Review Comments
Electrical Recommended Change Order #42
First fifteen plan sheets
{85R1,91R1,93R1,117R1,118R1,119R1,120R1,121R1,122R1,132R1, 133R1,141R1,142R1,154R1,172R1}
Michael Travis

MARK	DATE	DESCRIPTIONS	BY	CHK	CCO
A	8-06-07	Revision to misc. electric works. Clarity Interface between cable tray and conduit.	MP	EL	SO
		REVISIONS			42

DIST	COUNTY	ROUTE	KILOMETER TOTAL PROJECT	POST MILE	SHEET NO.	TOTAL SHEETS
04	SF	80	13.2/13.9	119R1	1204

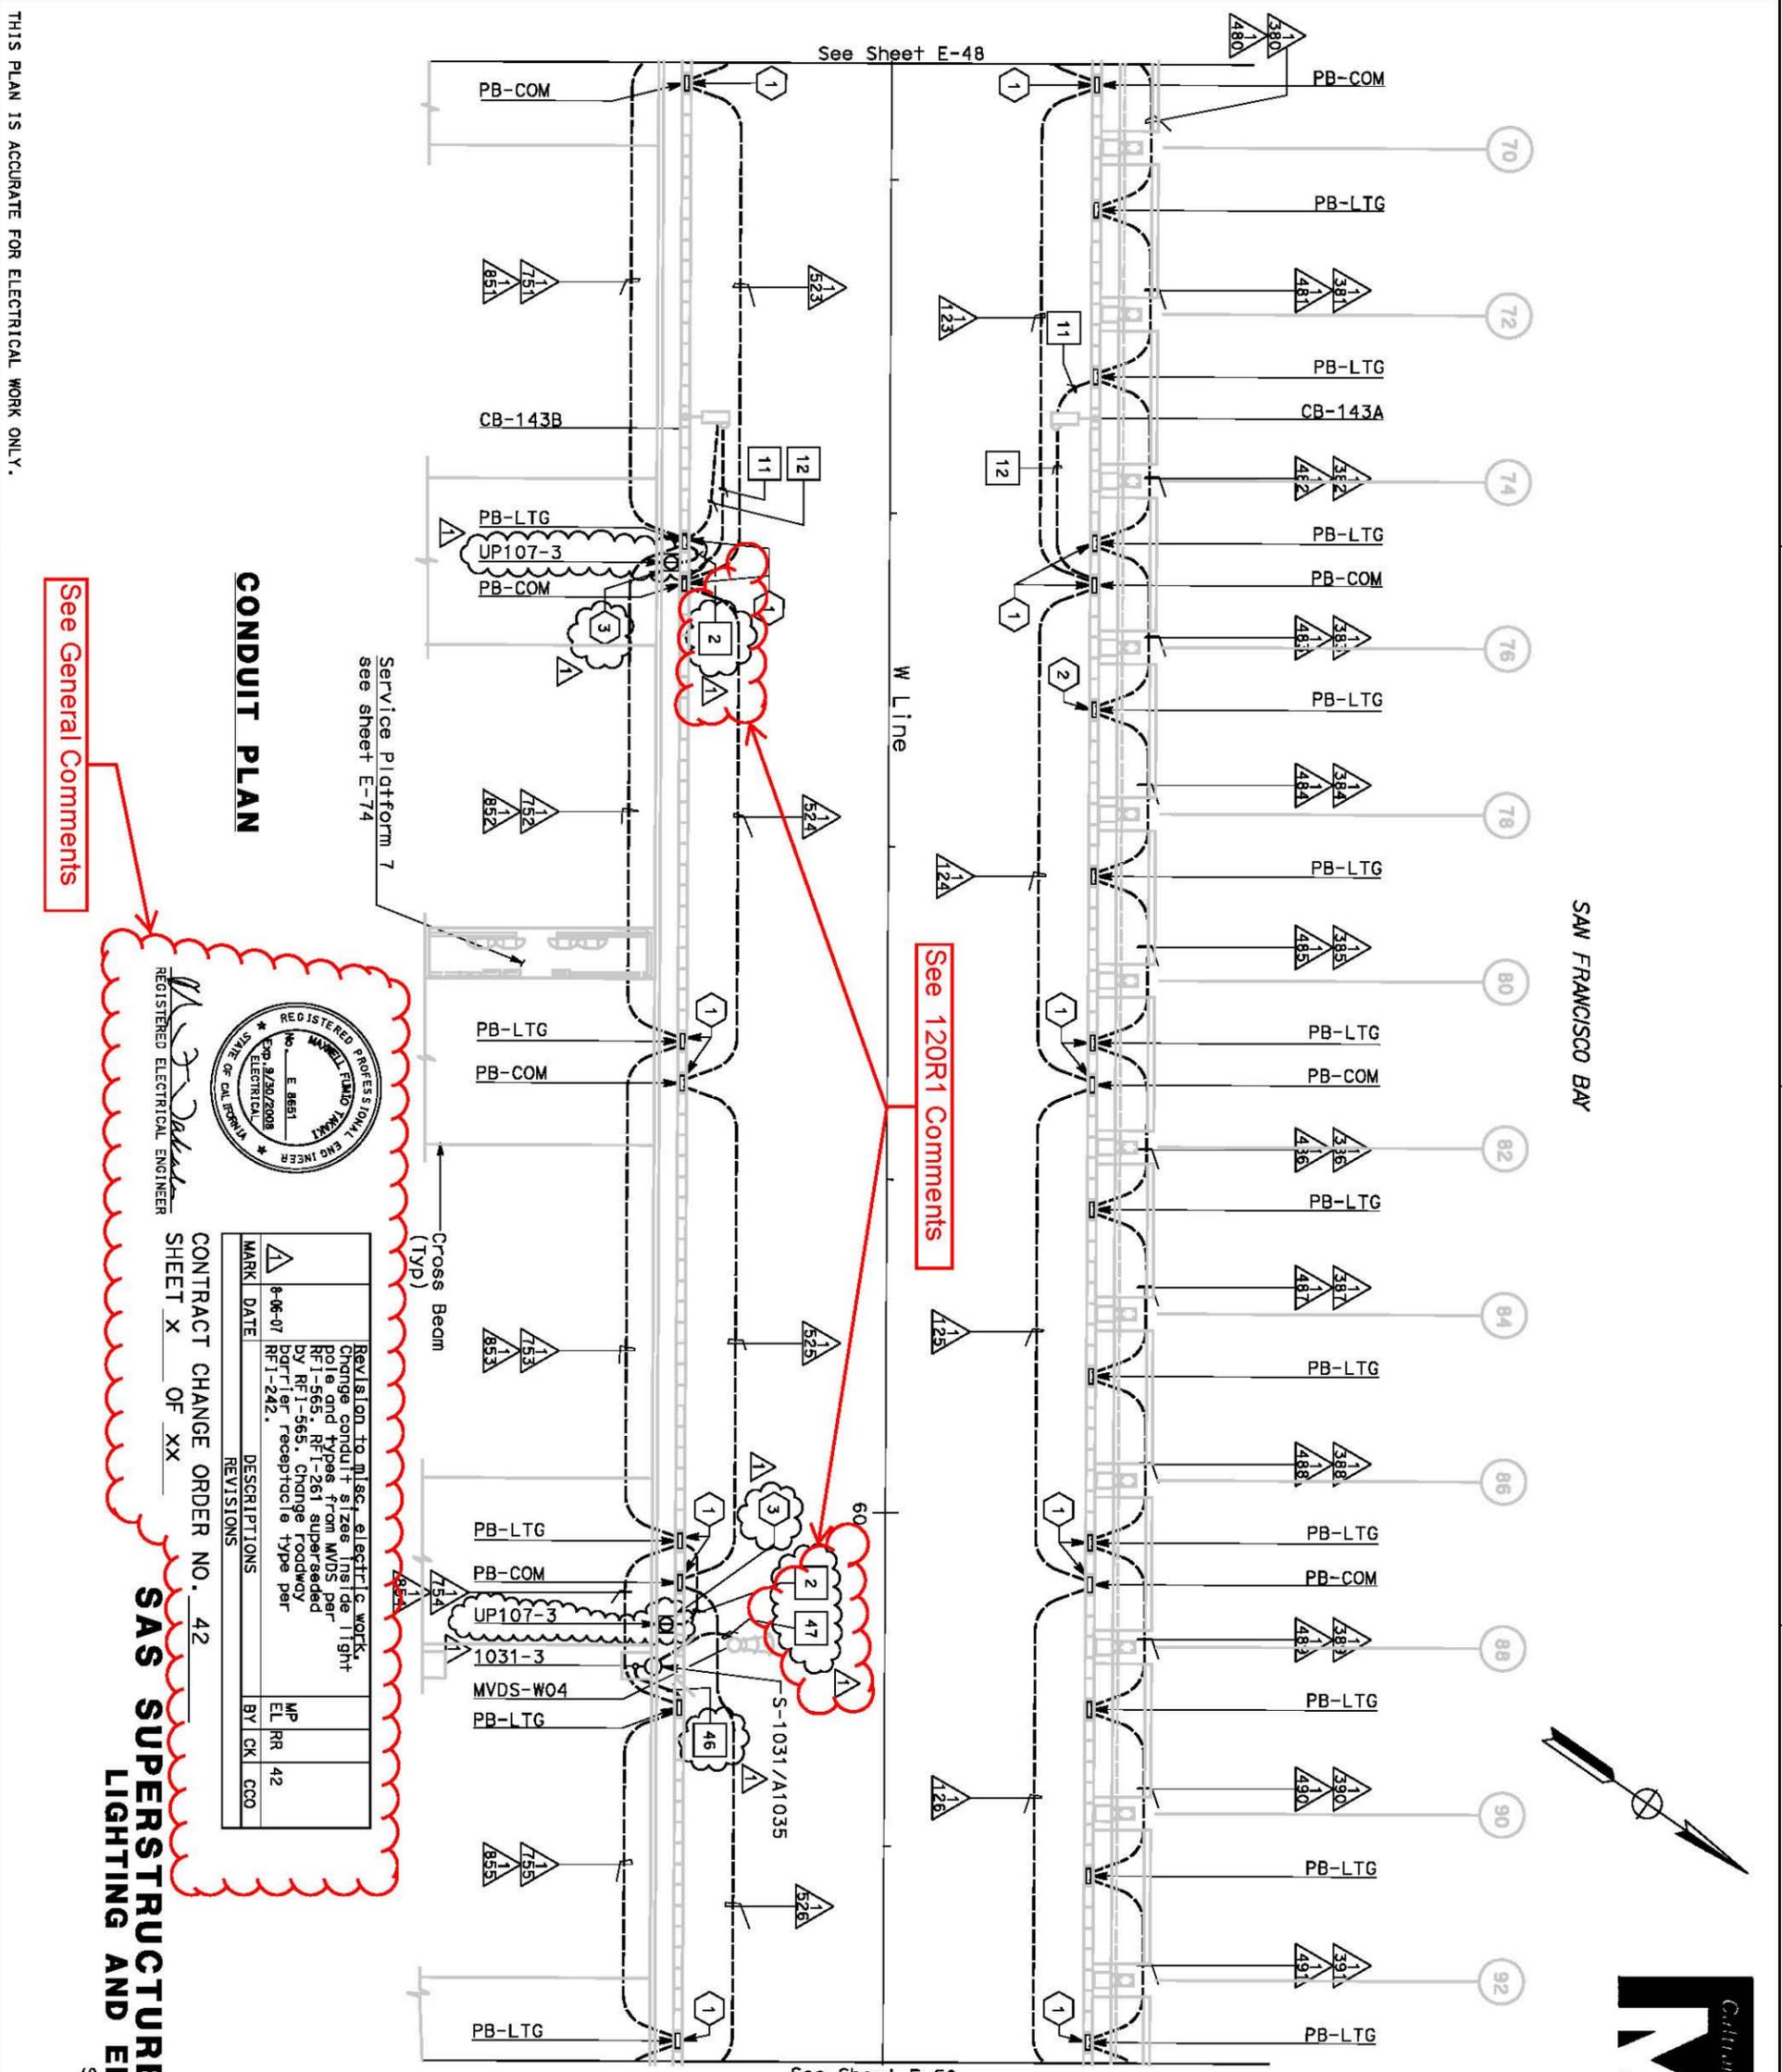
- ❖ The branch feed to the barrier rail receptacle has been changed in the CCO but was not clouded and indicated as a change. This changes the conductor feeds from #12's to #10. The conductors feeding this receptacle from the source (Panel board) is #8 conductors.

DIST	COUNTY	ROUTE	KILOMETER POST TOTAL PROJECT	SHEET NO	TOTAL SHEETS
04	SF	80	13.2/13.9	120R11	1204

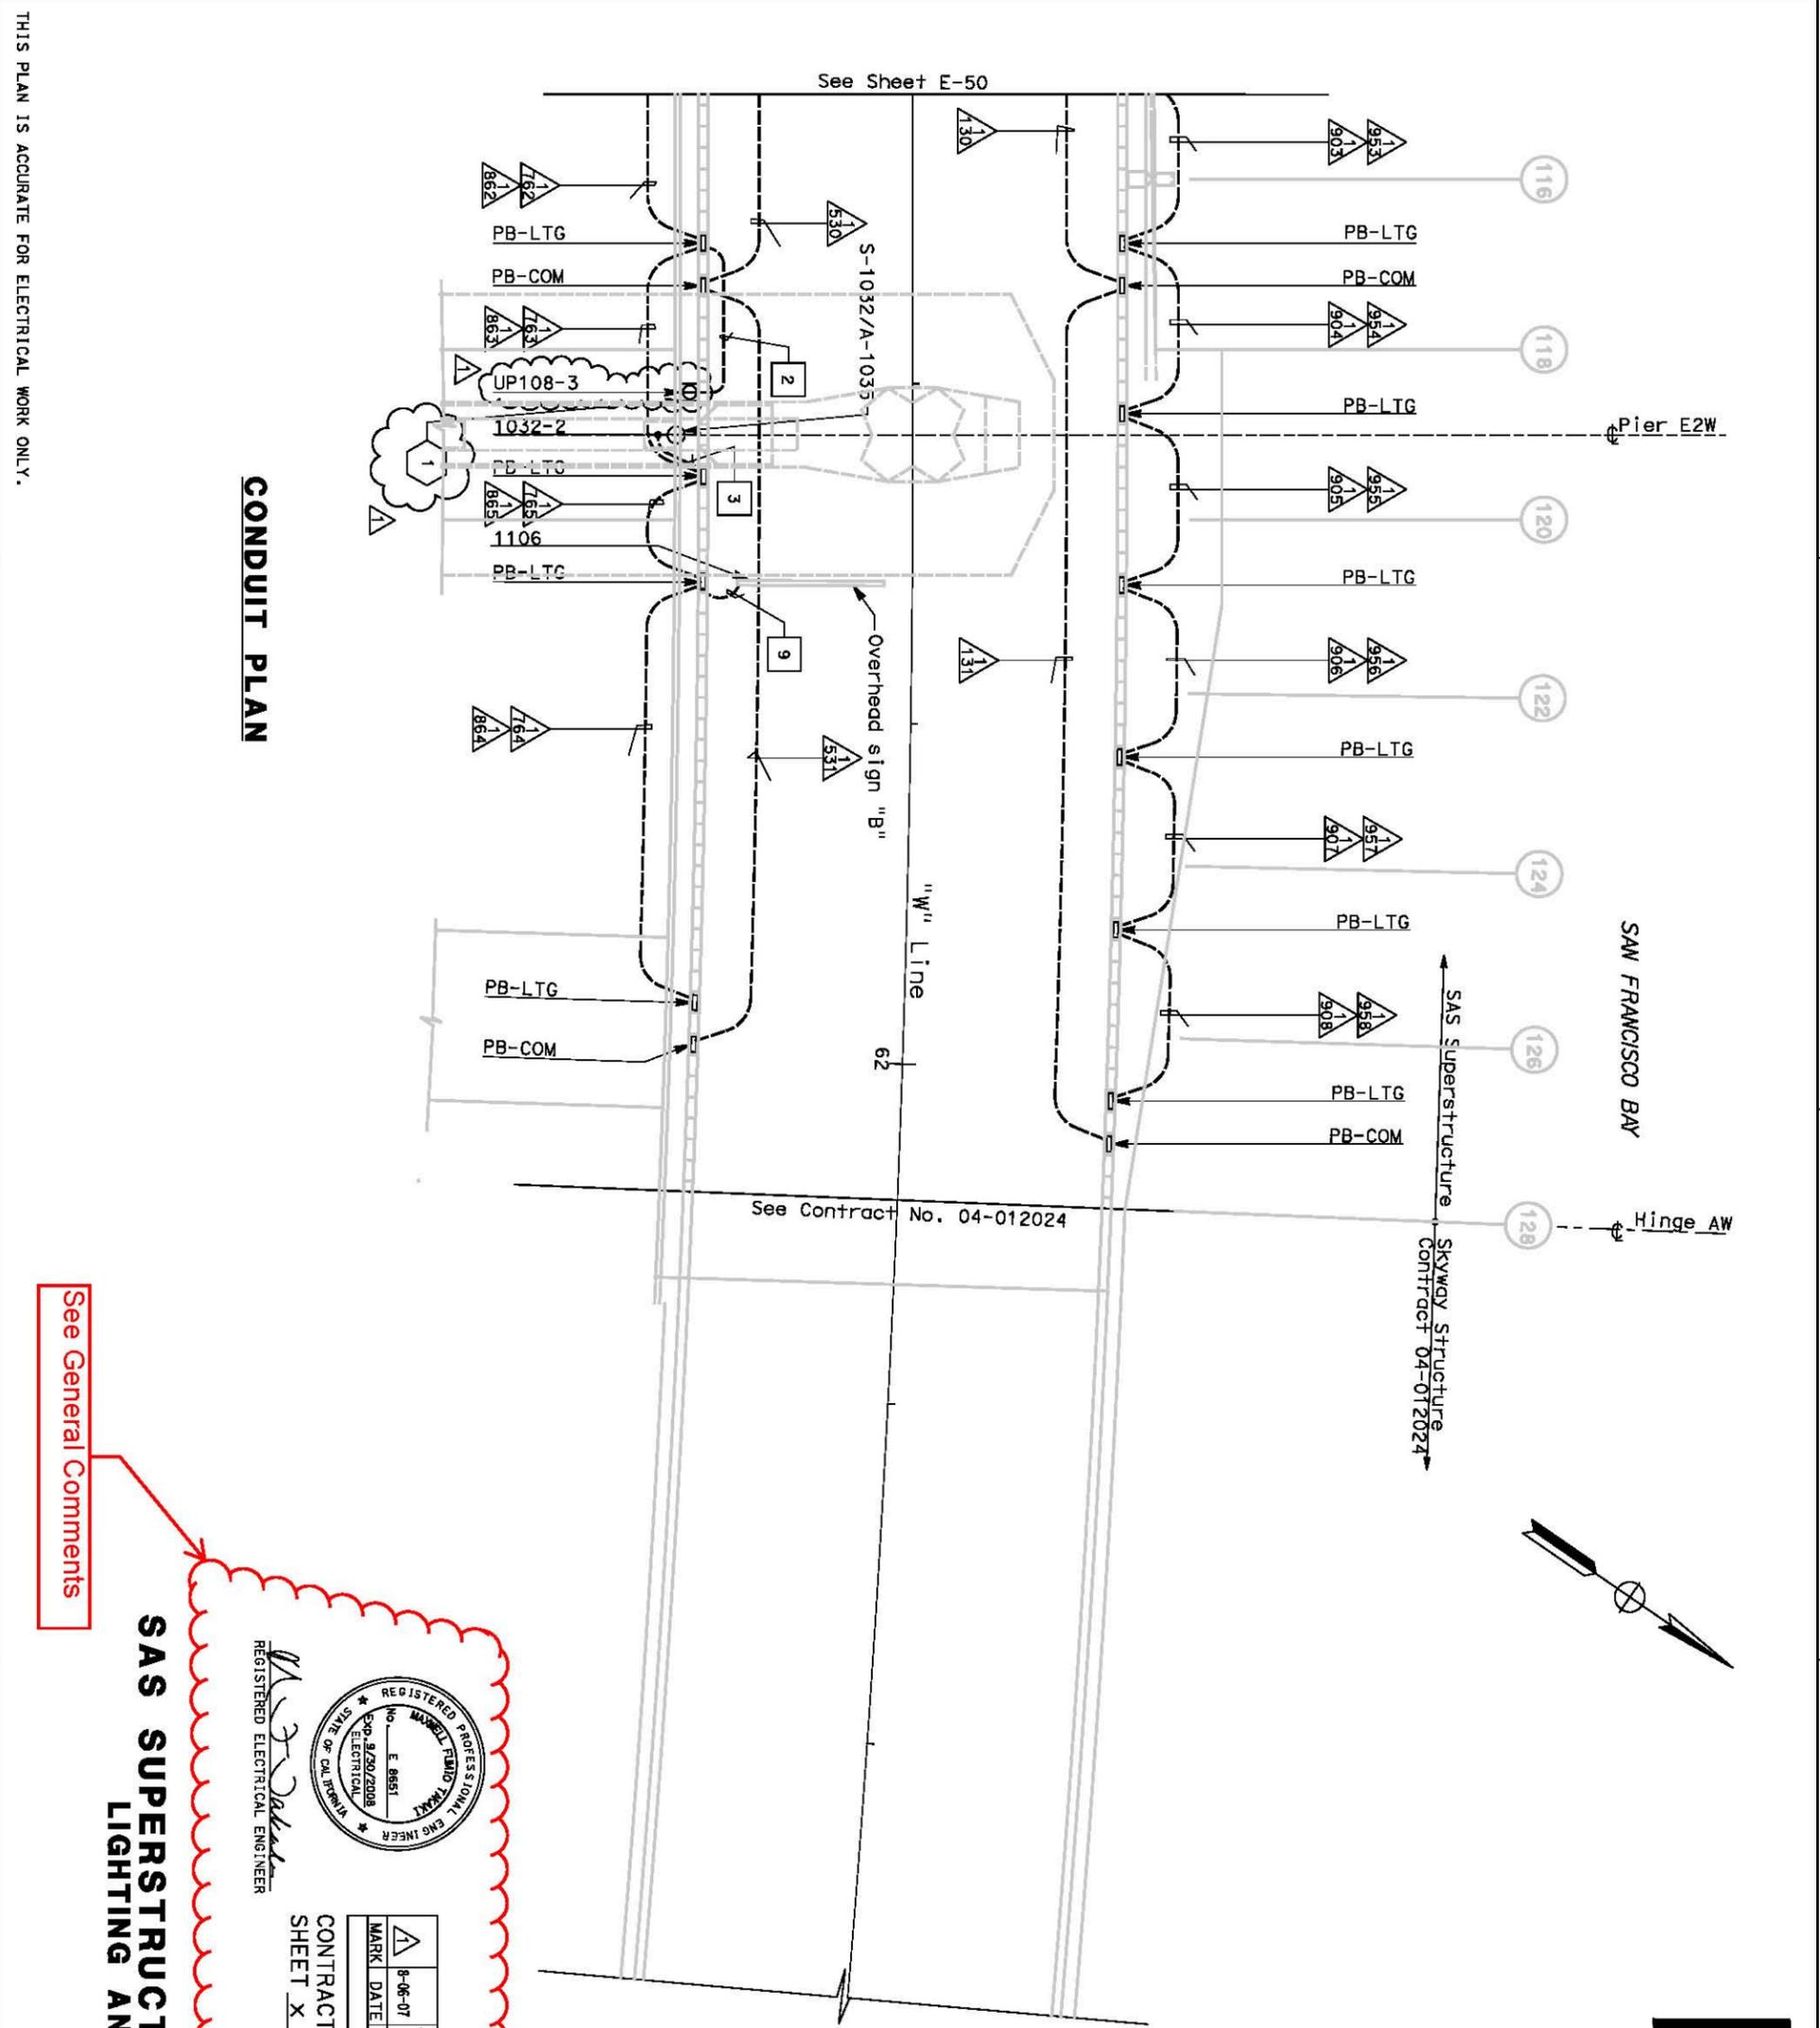
- ❖ The branch feed to the barrier rail receptacle has been changed in the CCO. The change is the conductor size from #12 to #10. The conductors feeding this receptacle from the source (Panel board) are #12 and have not been changed in the CCO. The change was not corrected to source. Was the intent to splice #10 conductors to the main feed?

DIST	COUNTY	ROUTE	KILOMETER POST TOTAL PROJECT	SHEET NO	TOTAL SHEETS
04	SF	80	13.2/13.9	142R1	1204

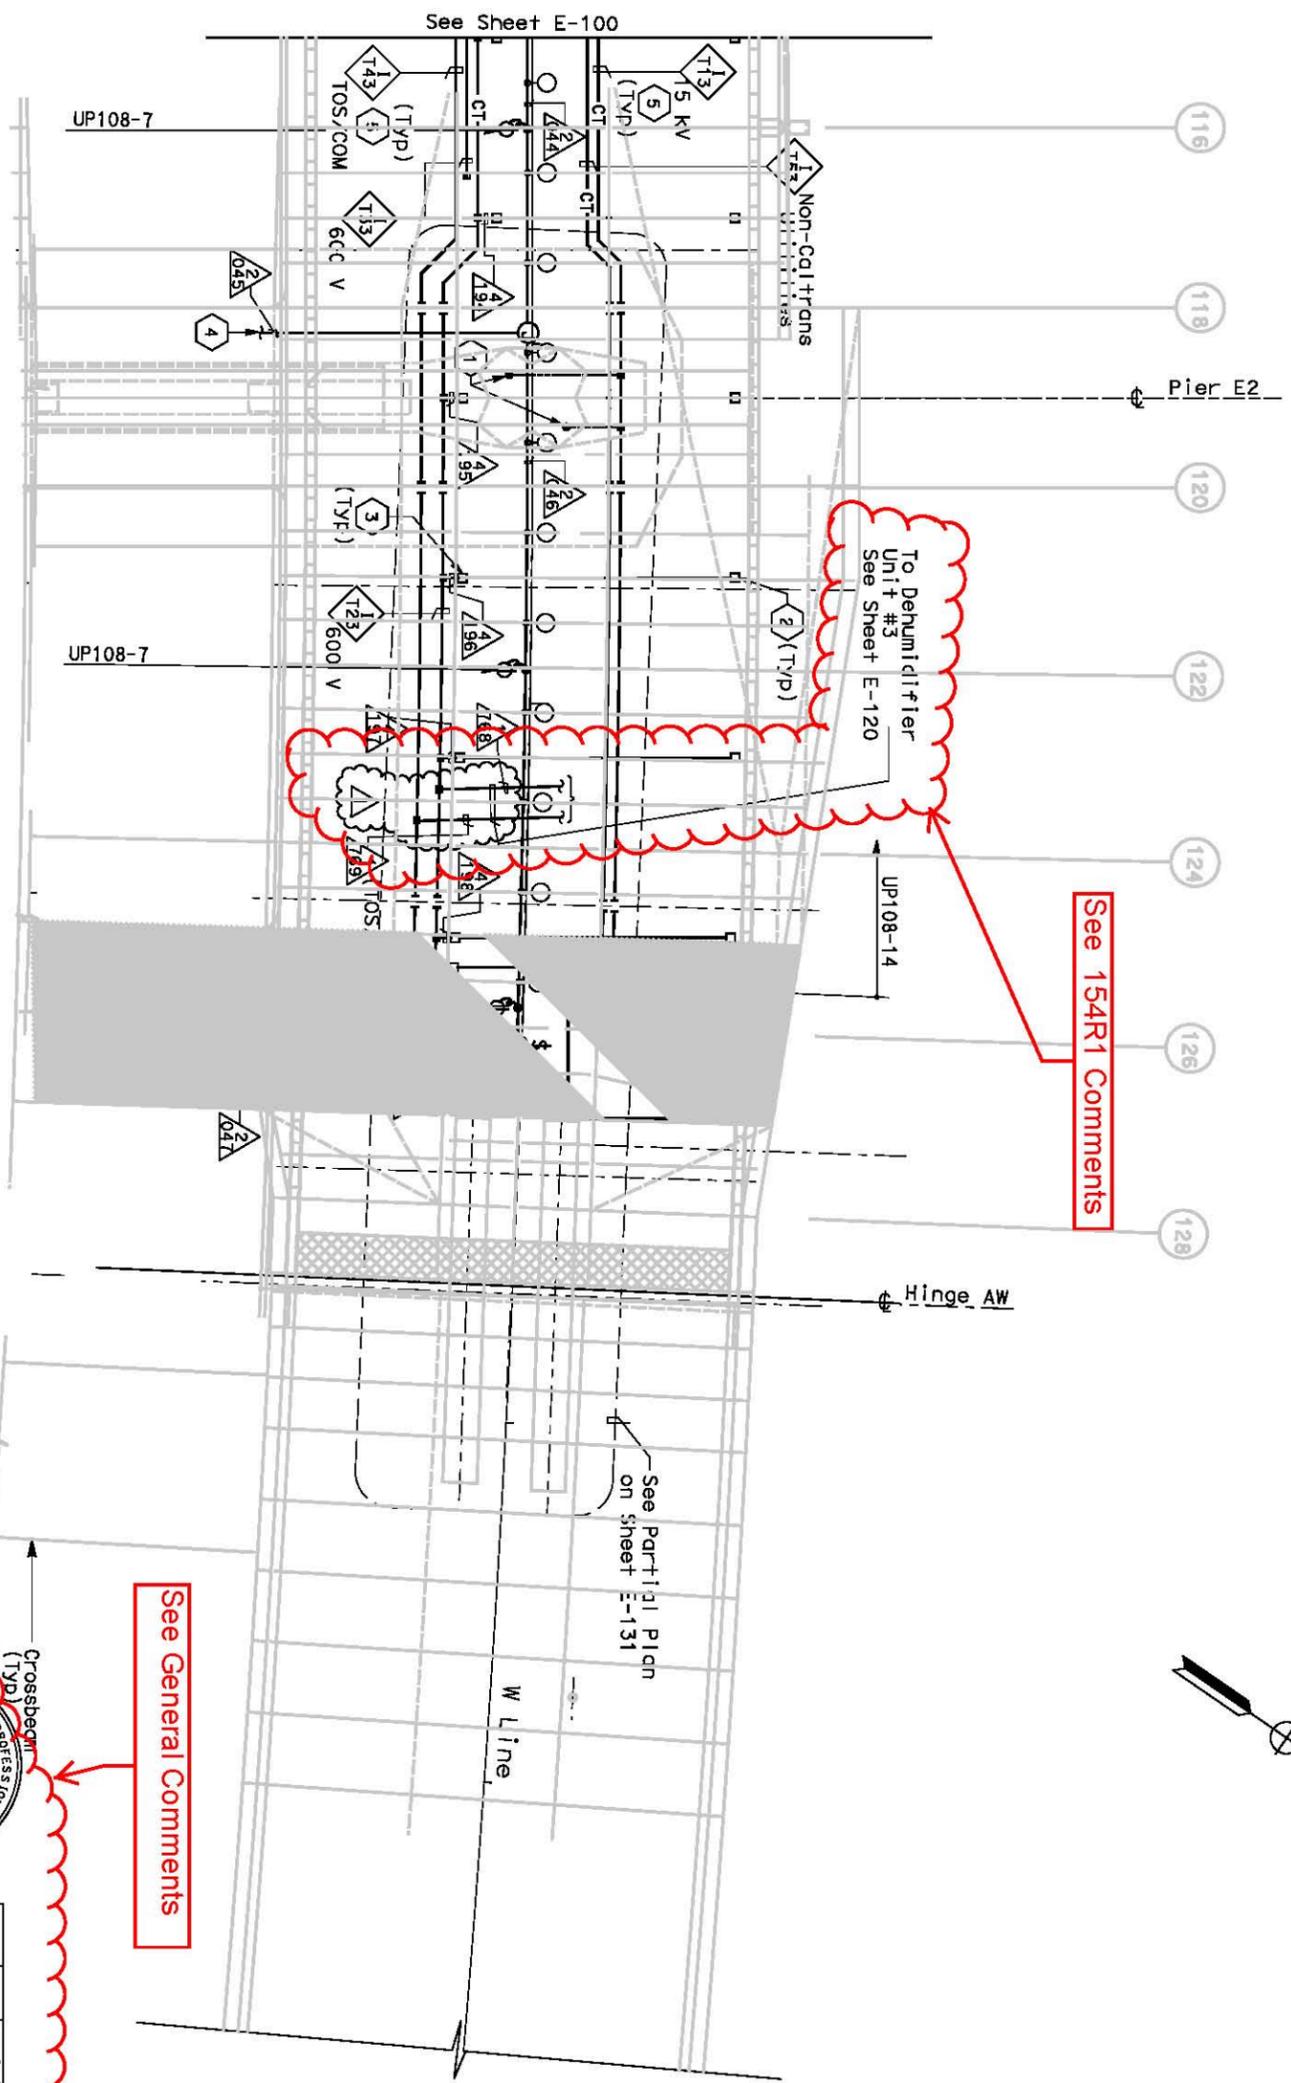
- ❖ This sheet has a reference to electrical sheet number E-209. This sheet does not exist and should be changed to sheet E-68.
